To: Plan Holders for Improvements to the
Rosecrans Memorial Airport
St. Joseph, Missouri
MoDOT Project No. 21-012A-2

Transmitted herewith is Addendum **No. 2** to the Issued for Bid Contract Documents, Specifications and Plans dated June 30, 2022, for Improvements to the Rosecrans Memorial Airport.

**ADDENDUM NO. 2
TO
CONTRACT DOCUMENTS, SPECIFICATIONS AND PLANS
FOR IMPROVEMENTS TO THE
ROSECRANS MEMORIAL AIRPORT
ST. JOSEPH, MISSOURI
MODOT PROJECT NO. 21-012A-1**

ELECTRICAL PLAN
STA. 45+40.00 TO STA. 53+20.00
RUNWAY 17/35

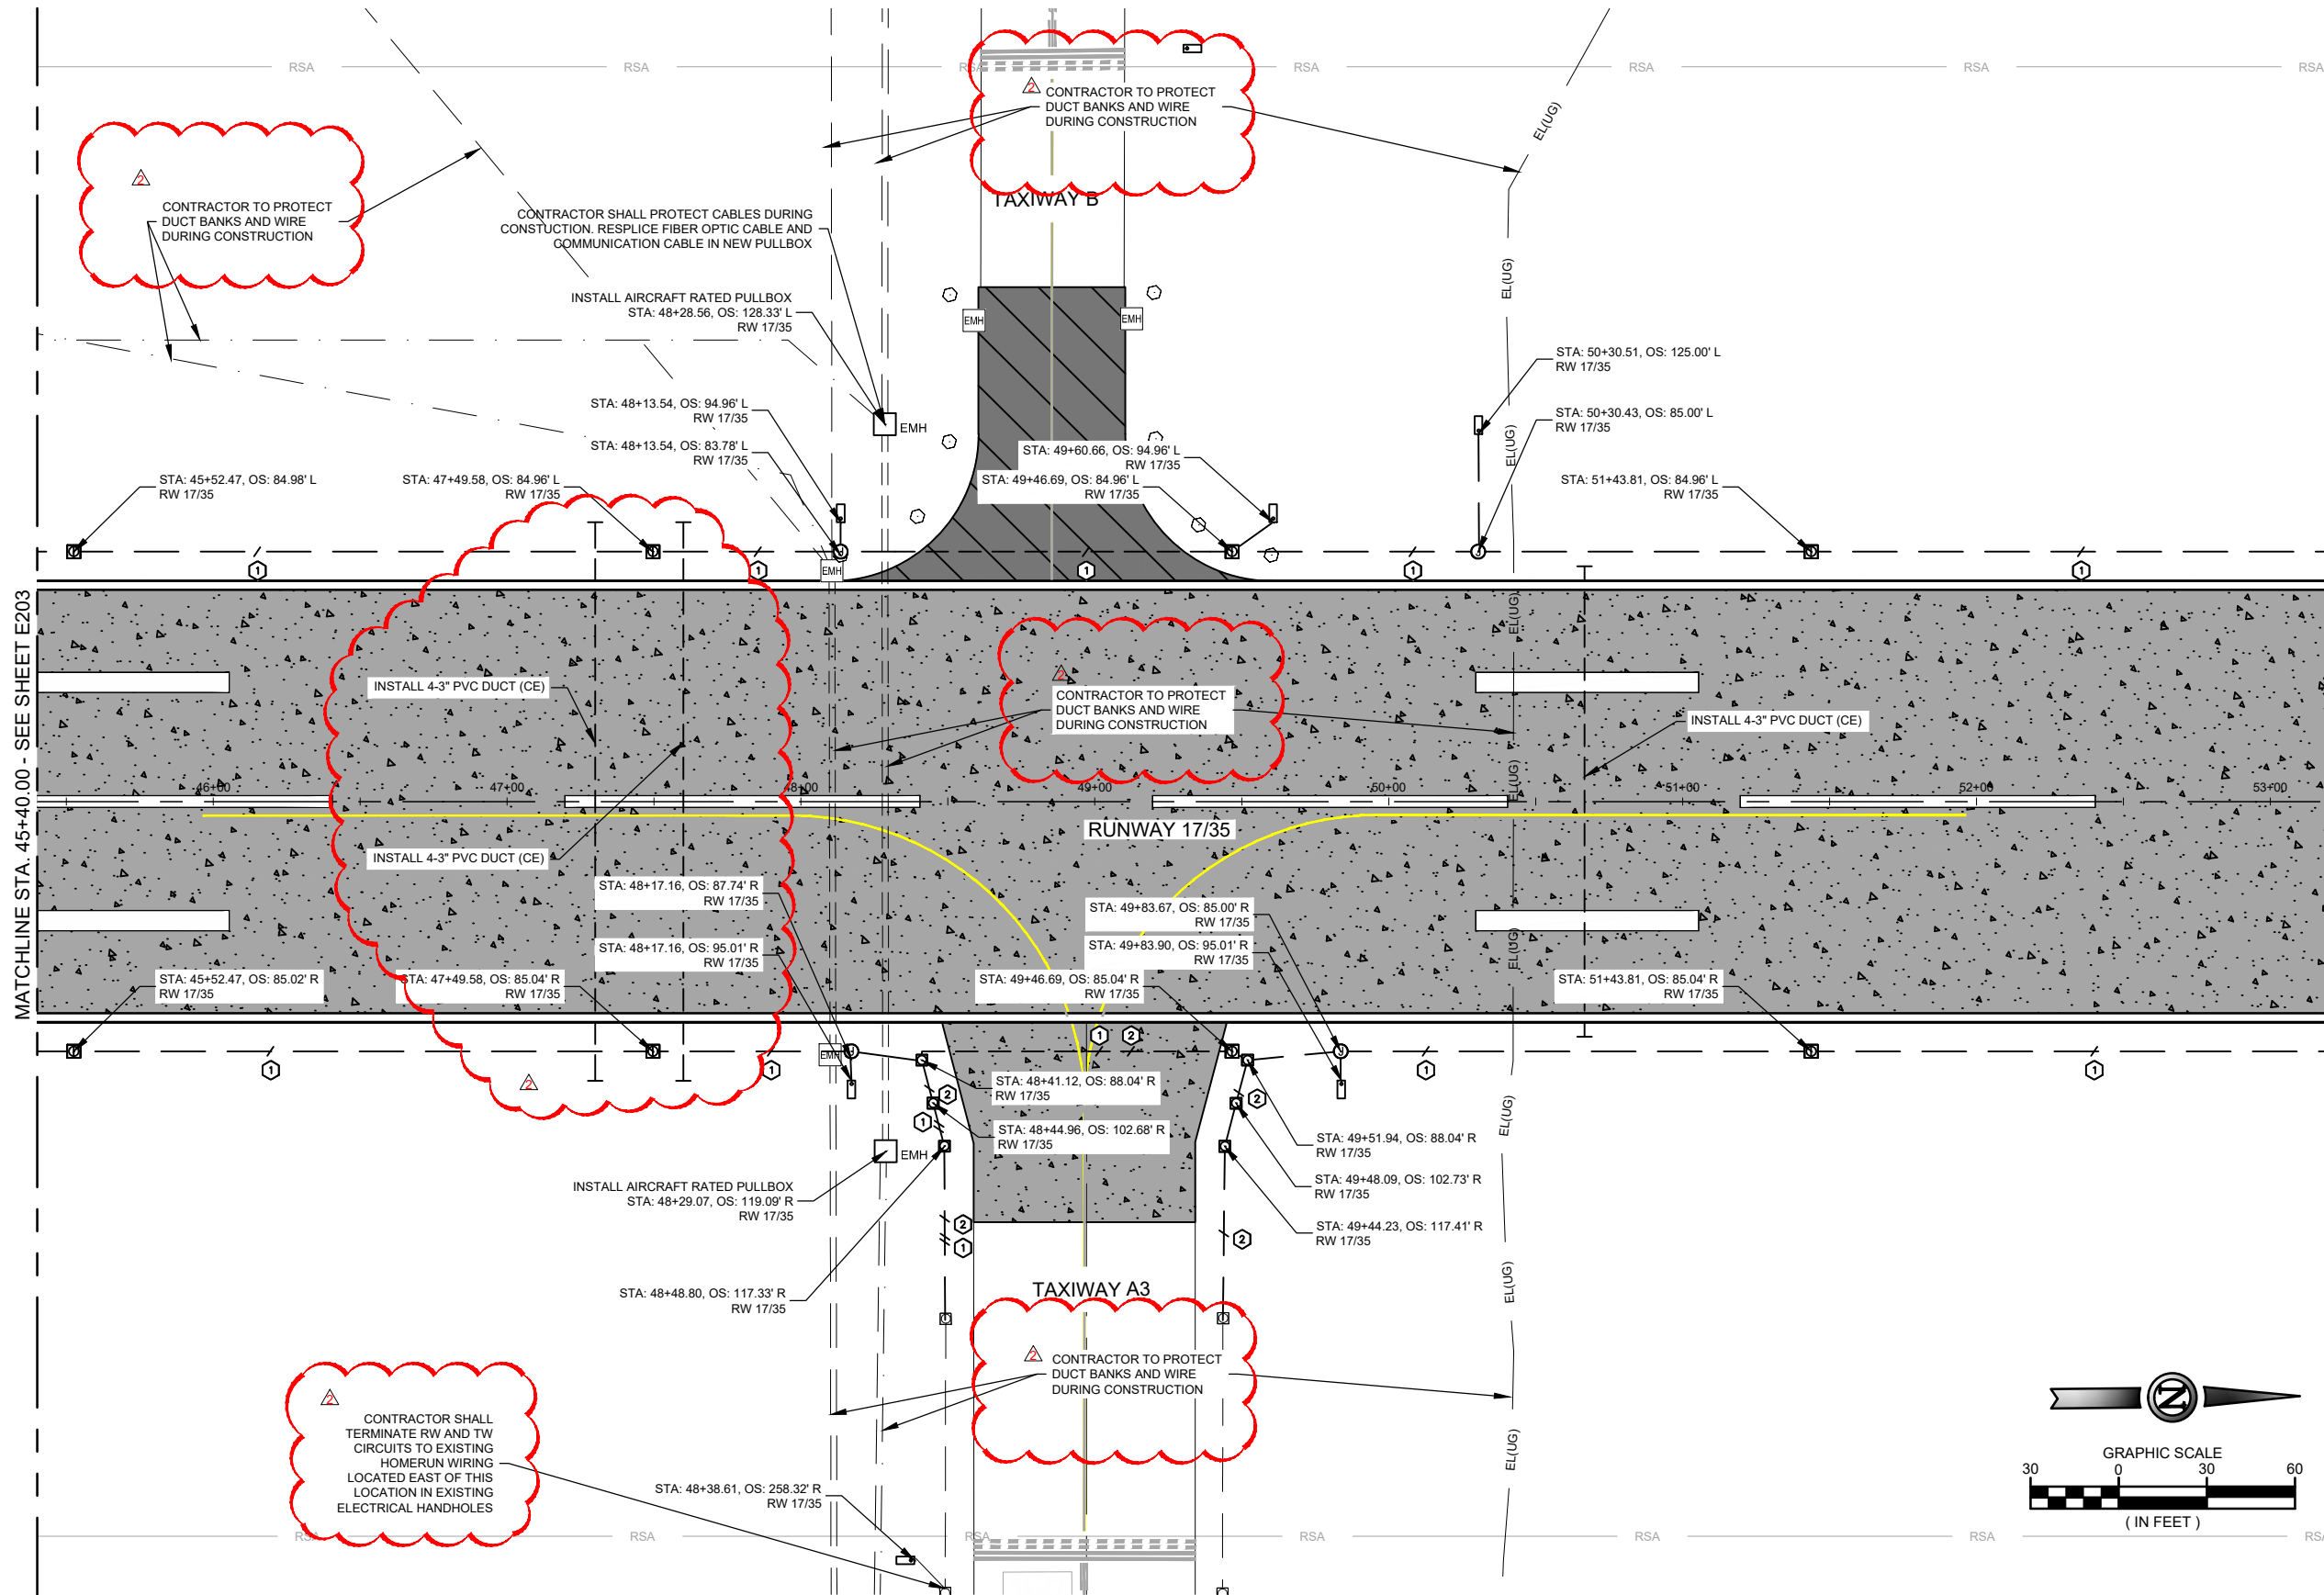
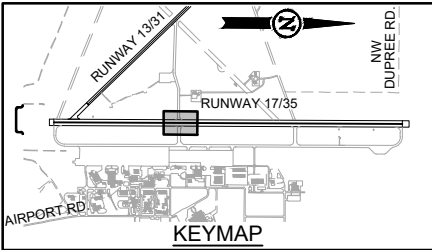
Revision: Duct was moved and added. Notes to protect utilities were added.

Justification: Duct was moved and added for future vault relocation. Notes were added to show protecting existing utilities.

FAA PAPI DETAILS
REFERENCE SHEET 009

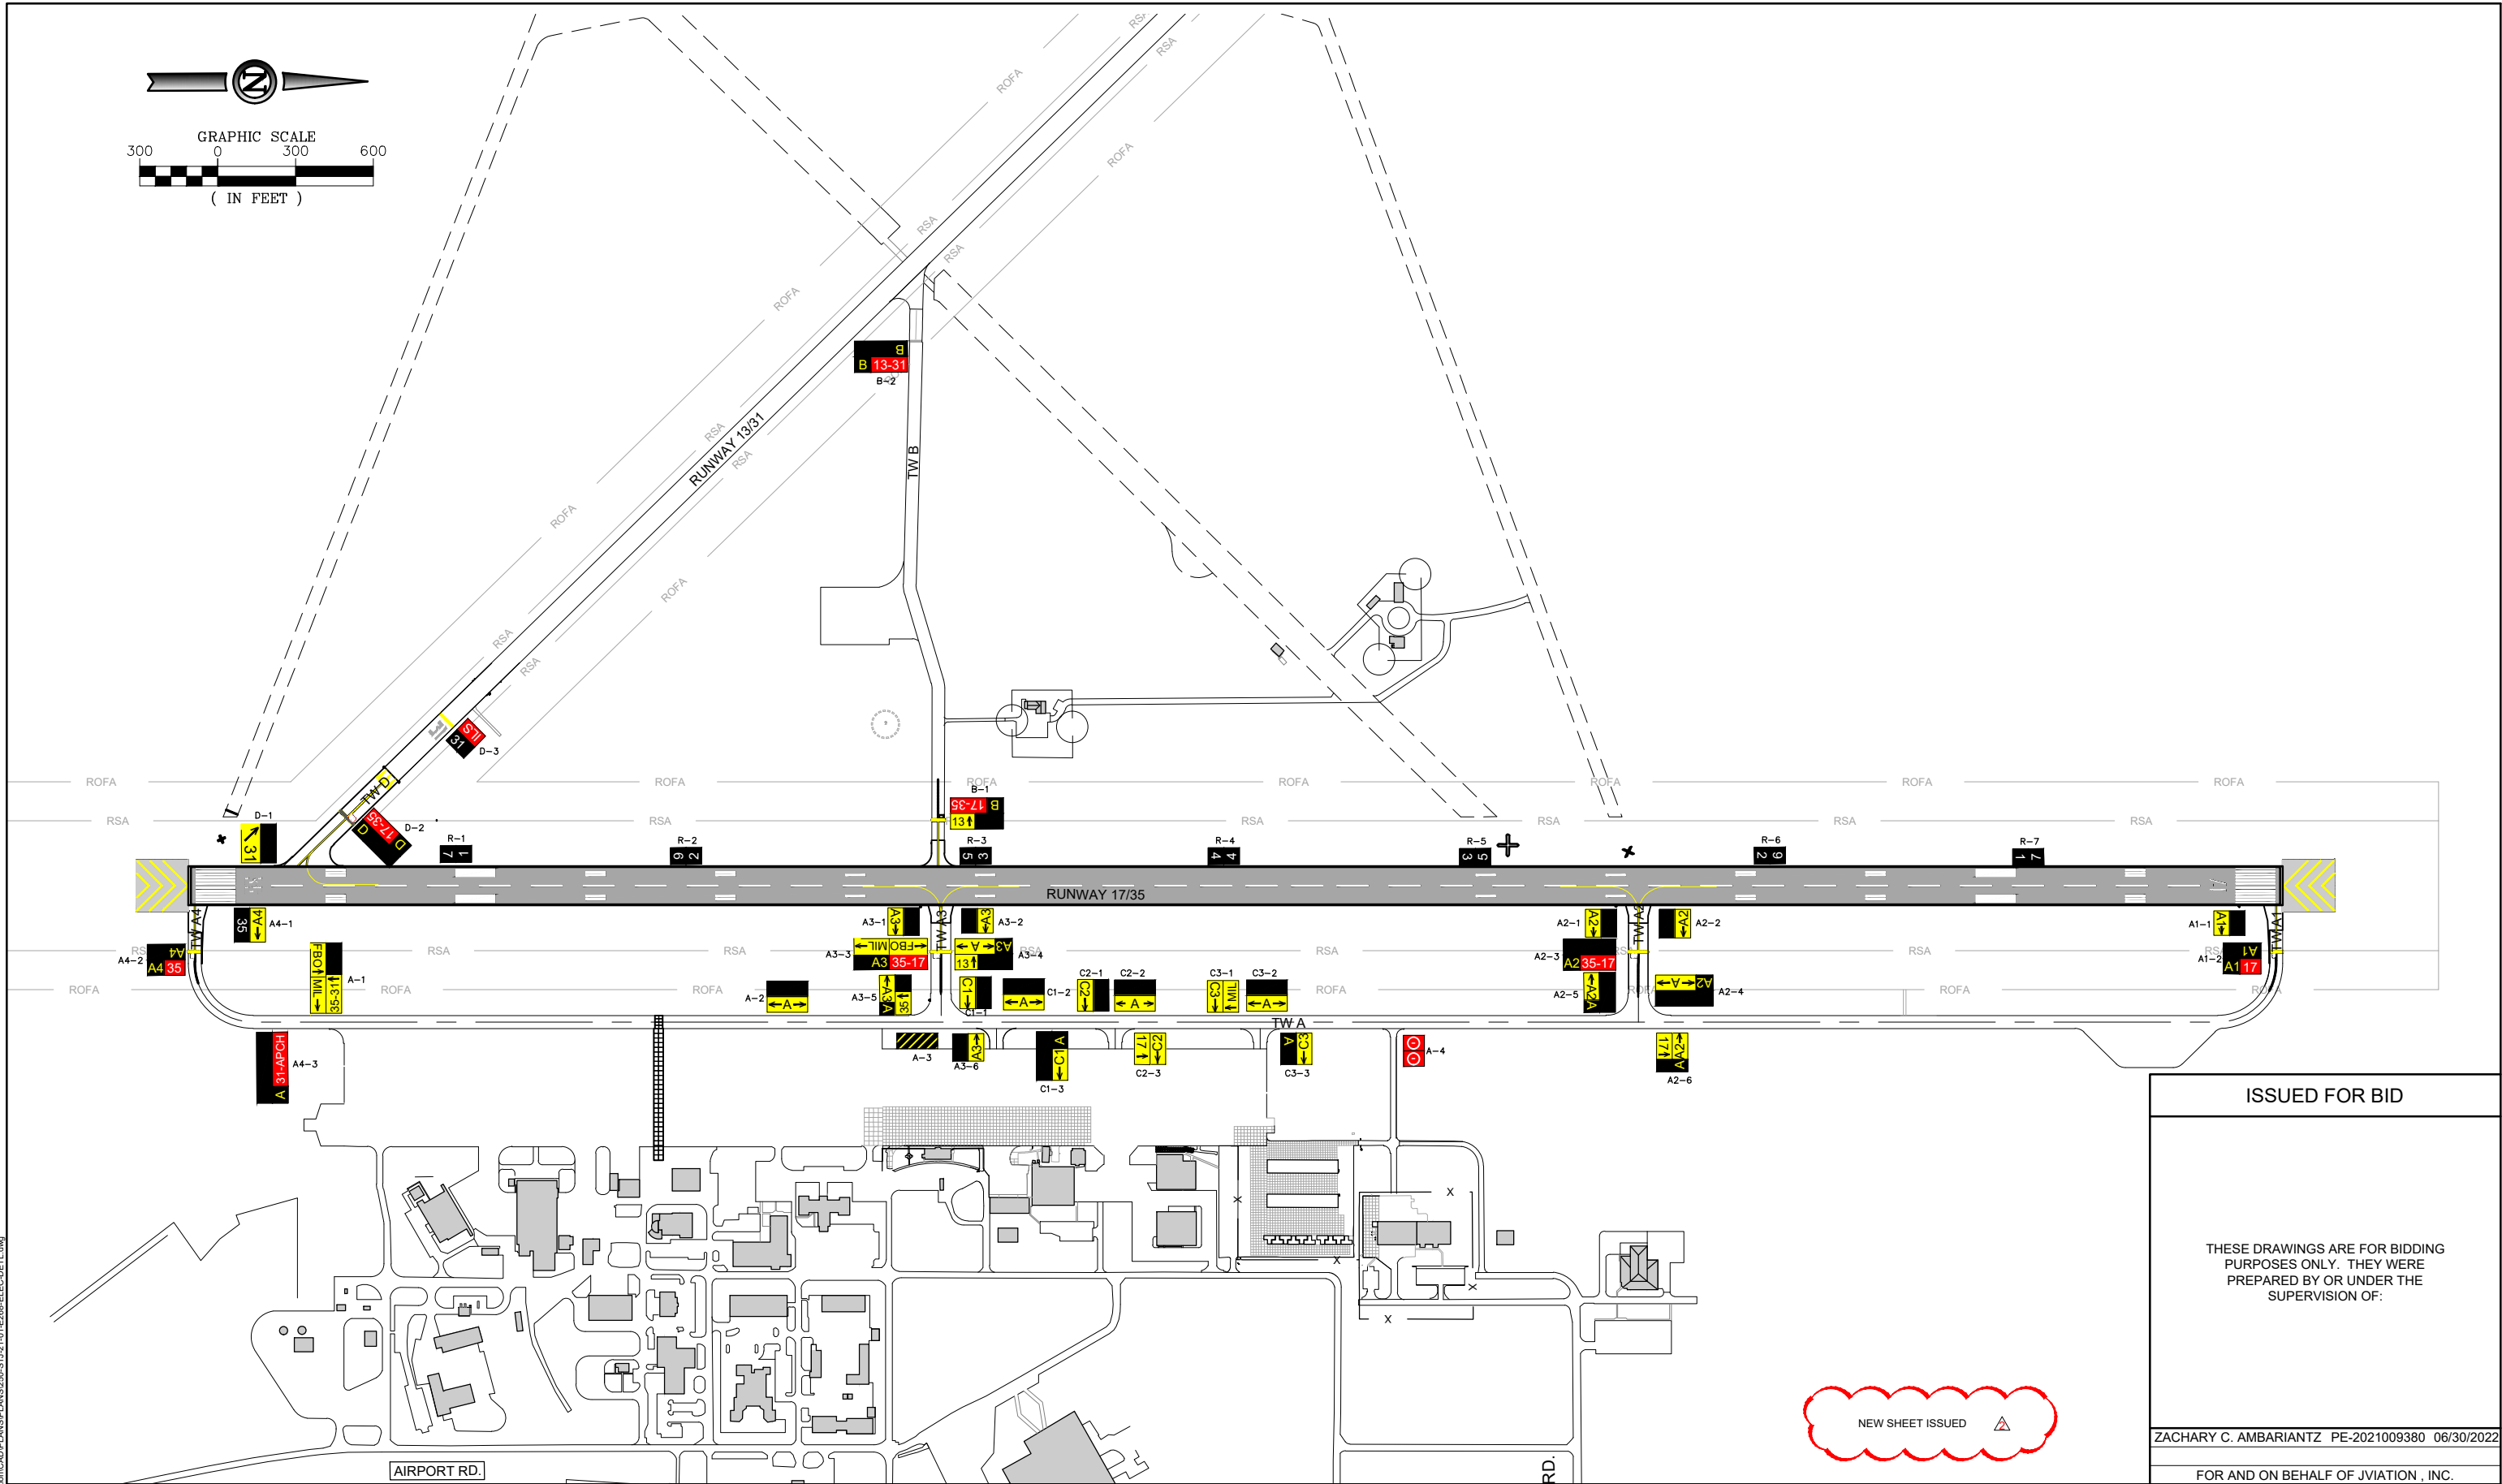
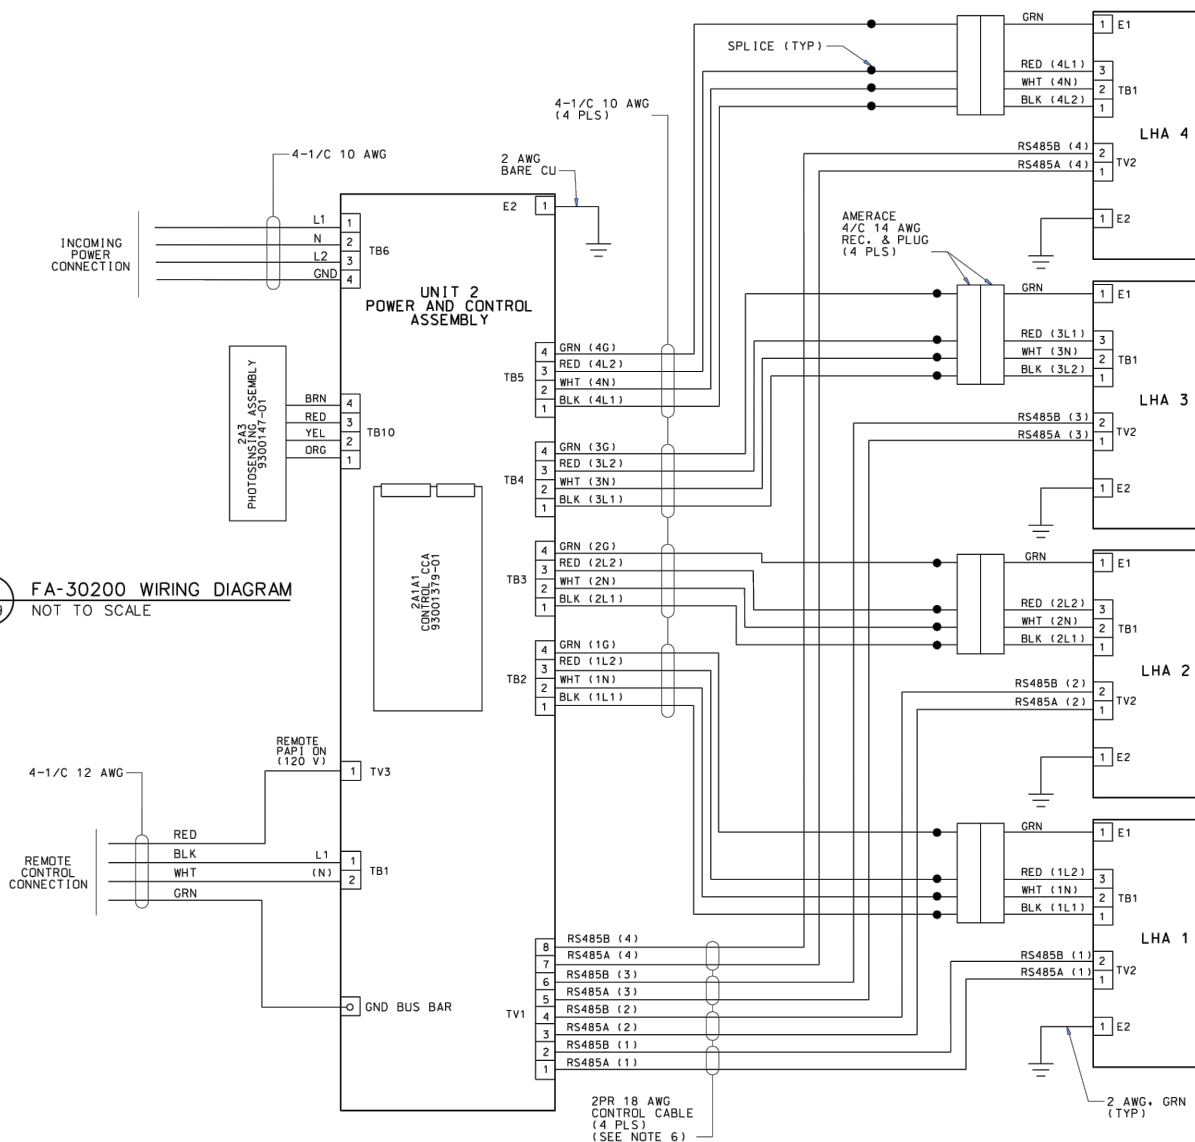
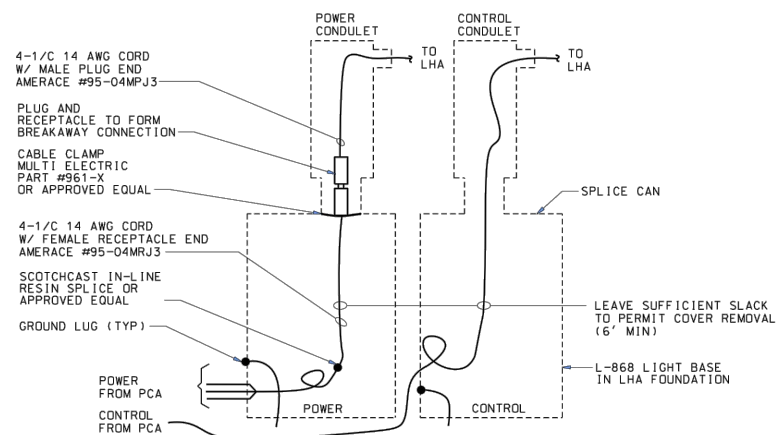
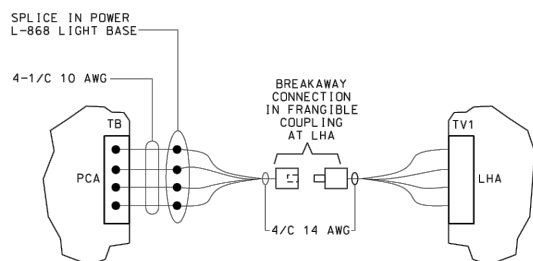
Revision: Sheet was added in its entirety.

Justification: Plan sheet shows additional wiring for the FAA supplied PAPIs.
